Access Compliance Report Public Rights-of-Way (Curb Ramps)

Intersection ID: 4743 Main Street: BELLHAVEN BV Cross Street: MT HOLLY-HUNTERSVILLE RD Location: ADA ID: 2834AA6C9074 Ramp Type: BlendTrans2 Initial Pass/Fail: Fail **Overall Compliance: No Severity Score:** 8.75

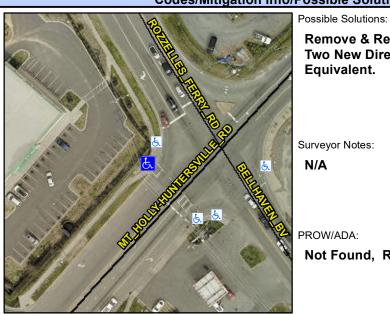
MT HOLLY HUNTERSVILLE RD Street 1 Name Stop Condition-Street 1 Signal Street 2 Name N/A Stop Condition-Street 2 N/A Remove & Replace Curb Ramp With **Two New Directional Ramps or** Equivalent.

Not Found, R304.5.1
